**PLEASANT PRAIRIE PLAN COMMISSION MEETING
VILLAGE HALL AUDITORIUM
9915 39th AVENUE
PLEASANT PRAIRIE, WISCONSIN
6:00 P.M.
MARCH 9, 2015**

- A. Consider the request of Peter Kucha, of Eppstein Uhen Architects, Inc., agent for Uline for approval of **Preliminary Site and Operational Plans** for mass grading and preliminary approval of an office building and site improvements for a Uline Headquarters Office building (H2) generally located at the 11200 block of 120th Avenue (West Frontage Road).

Consider the request of Peter Kucha, of Eppstein Uhen Architects, Inc., agent for Uline for approval of **Preliminary Site and Operational Plans** for mass grading and preliminary approval of an office building and site improvements for a Uline Headquarters Office building (H2) generally located at the 11200 block of 120th Avenue (West Frontage Road).

ONSITE CIVIL ENGINEERING INFRASTRUCTURE PLANS

SHEET C-7
C-14

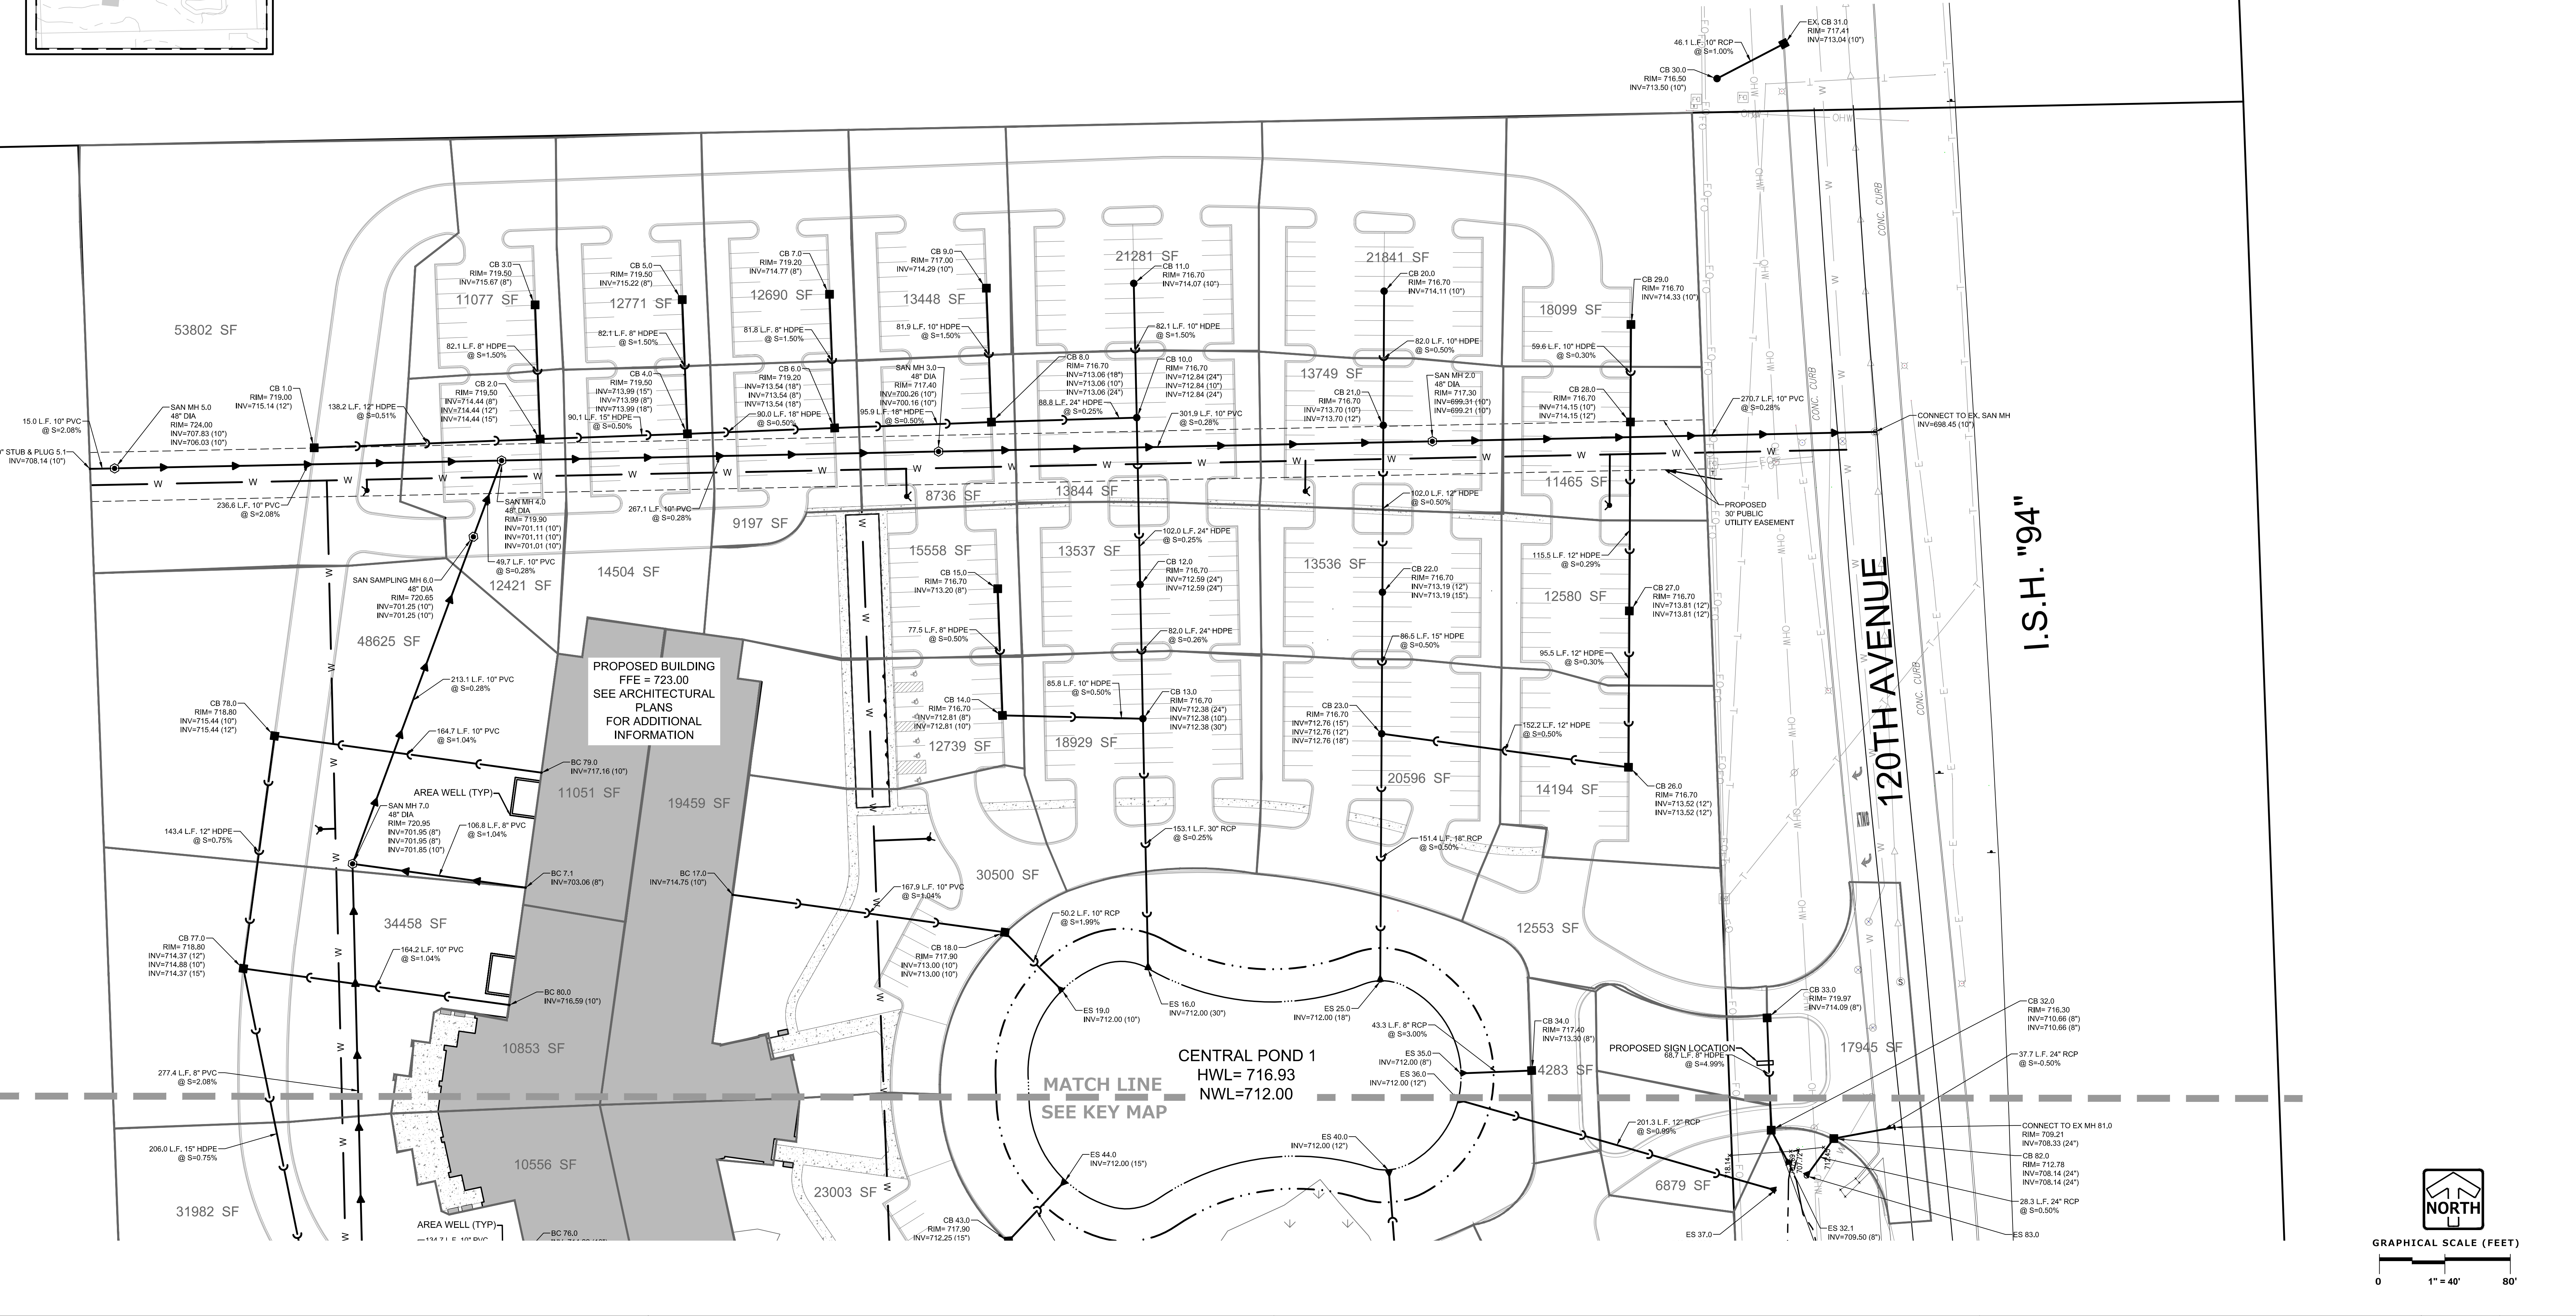
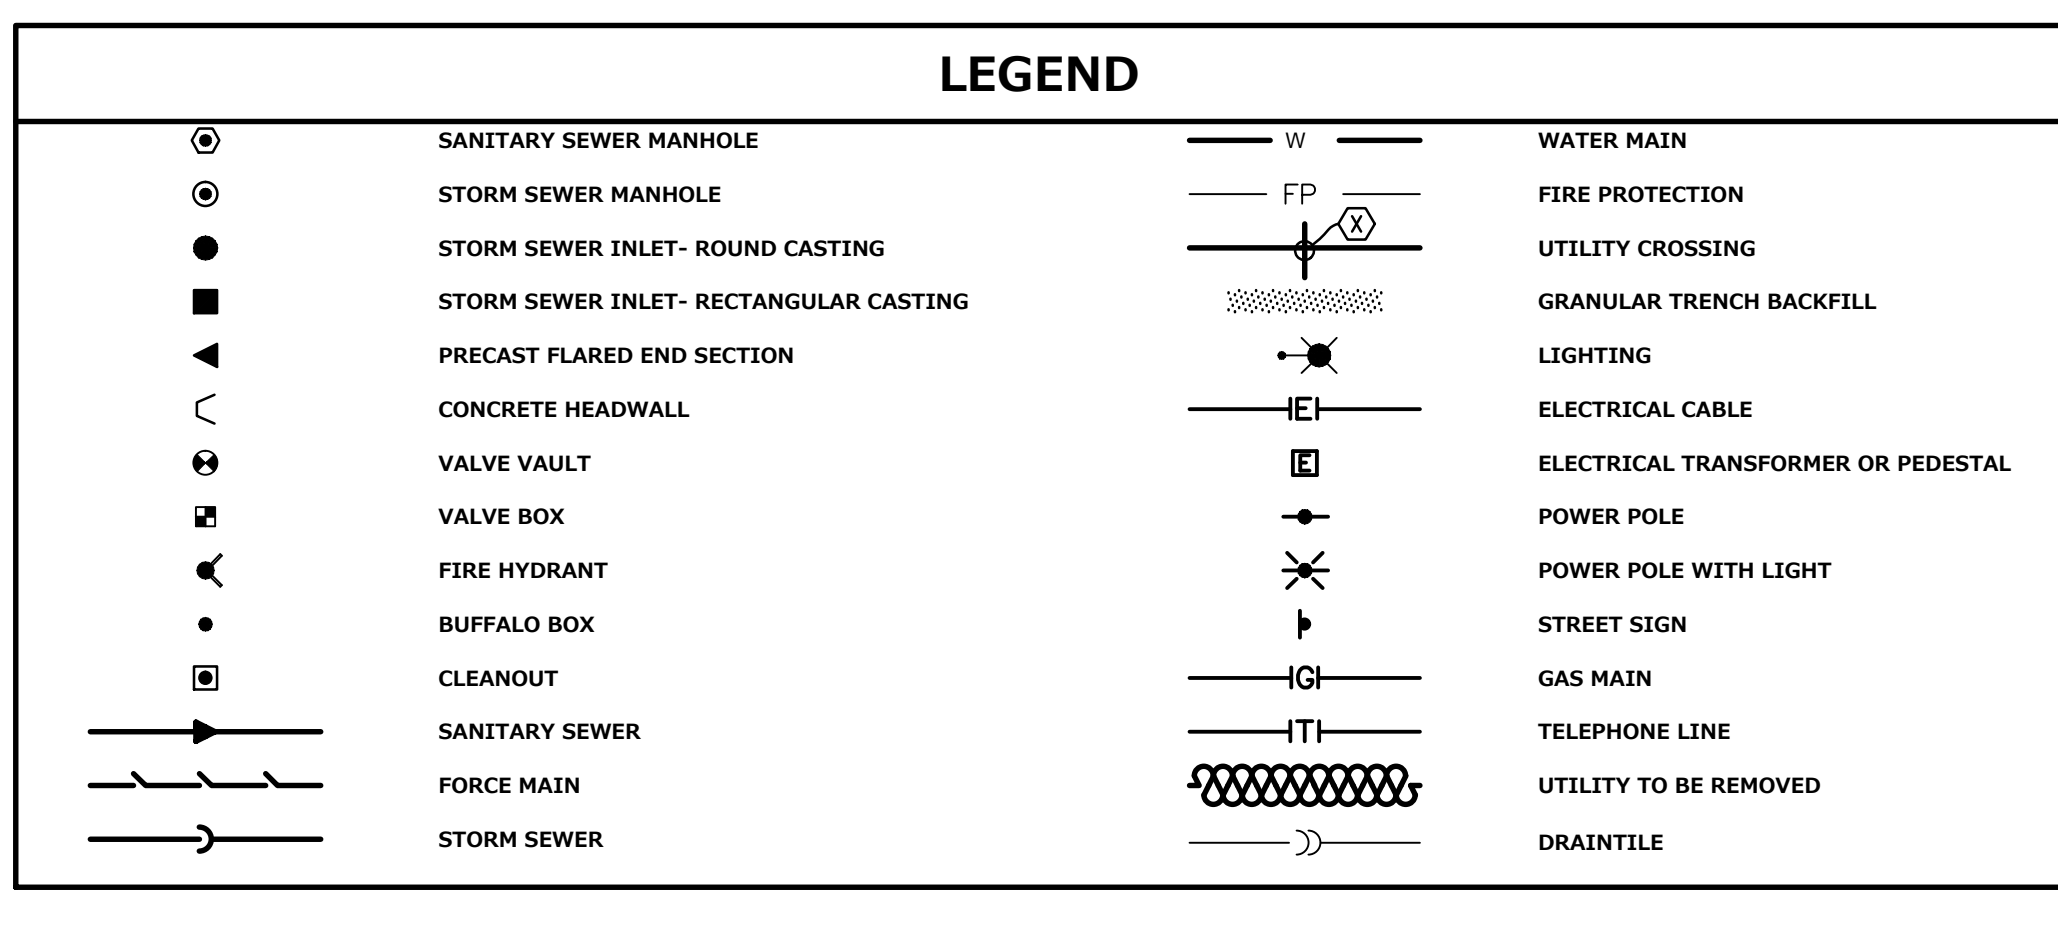
way. Also, on Sheet C-7 it appears that the sign is located on top of the storm sewer.

- iv. Utility Plan (Sheets C-7 & C-8):
 - (1) Show locations of known drain tile connections to the storm sewer.

- (4) Provide plan and profile(s) for the public sewer and water main.
- (5) Clarify the purpose of CB 30.0? It is located north of the quarter section line and it appears not to be at a low point.

- (6) Show existing storm sewer(s) on the plans sheets.
- (7) Label proposed water main information.
- (8) All storm sewers within the right of way shall be RCP (minimum of CL III).

REG. JOB NO. 119.00A
 REG. NO. ABA
 START DATE 12/20/14
 SCALE
SHEET C-8
C-14
UTILITY PLAN

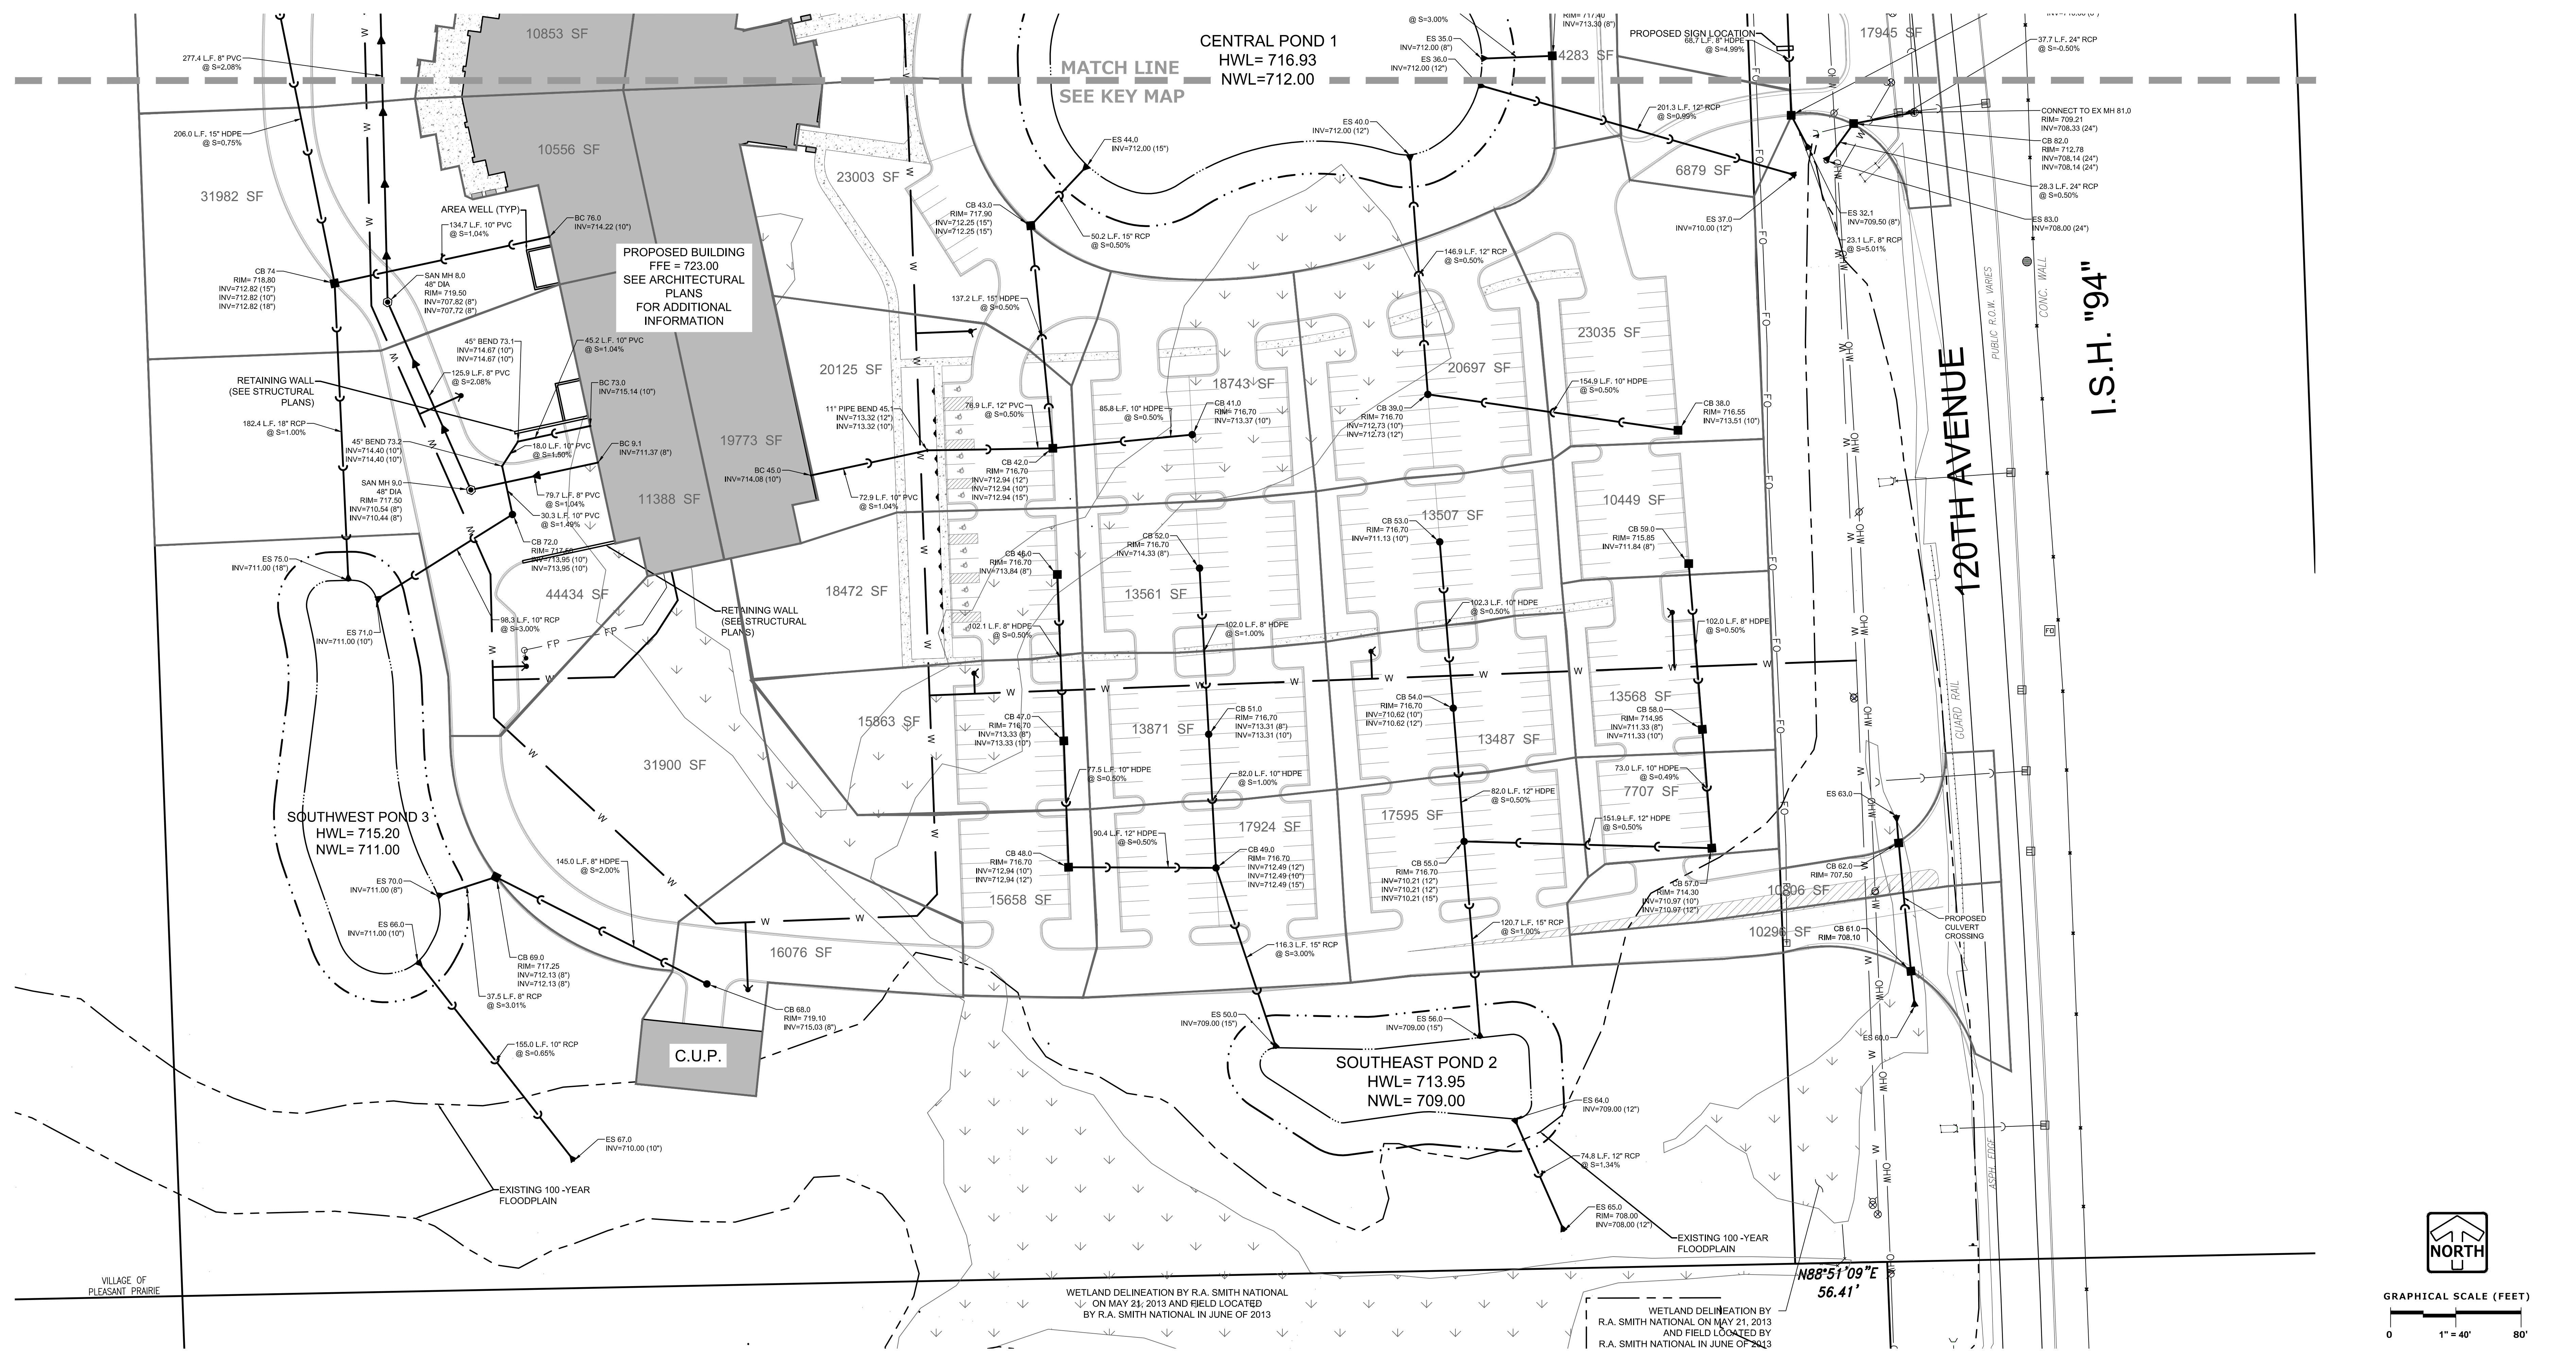
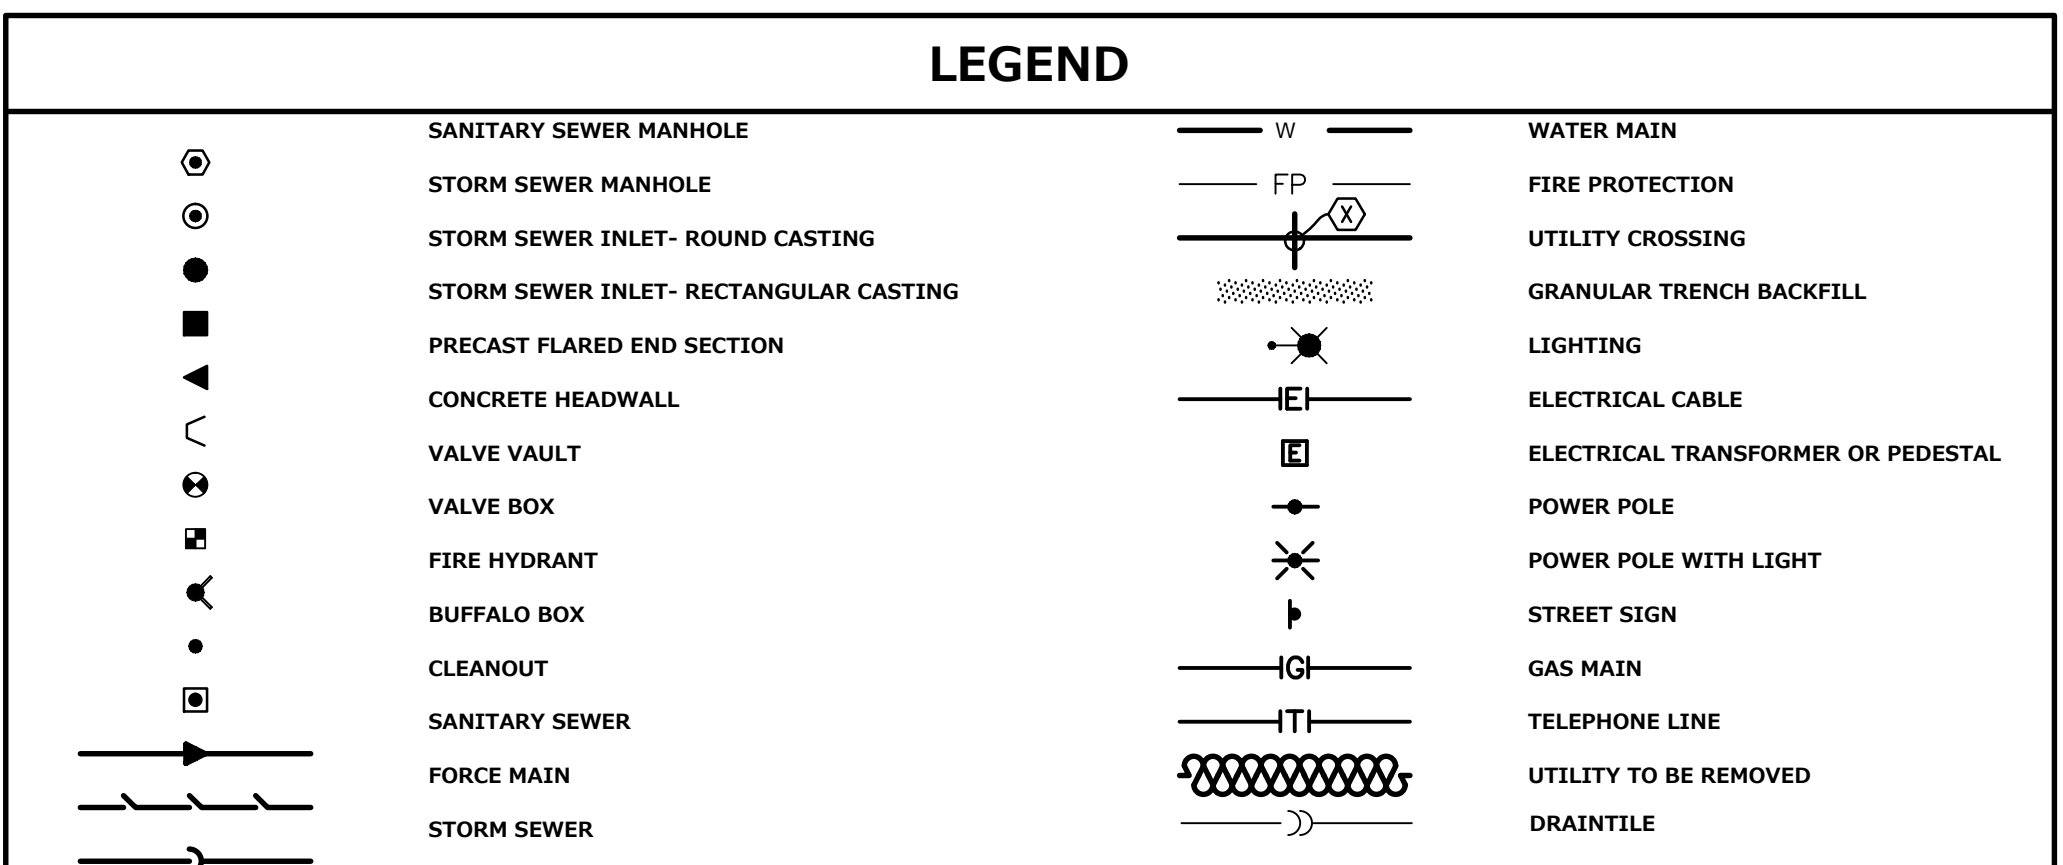
- (1) Replace the Village Hydrant Detail with the updated version (See **attached**).
 - (2) The outlet pipe size noted for pond 3 does not match the pipe size labeled in sheet C-8. Correct the mislabeled size.
